ATTACHMENT C -- PROPOSED DRAWING CHANGES

(MARKED-UP SPECIFICATION)

Amend of the Fig. 4
(prolong the dotted line)

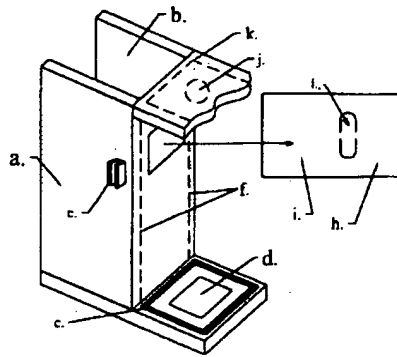
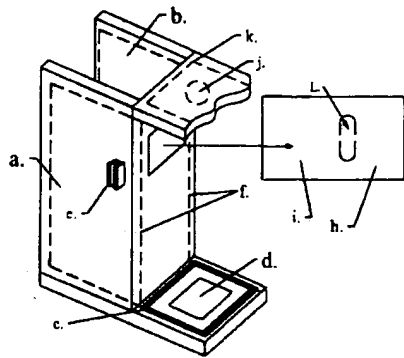
Approval of the proposed drawing changes marked in red on the following copies of Figures x-y and prolong the dotted line of Fig.4 f are respectfully requested.
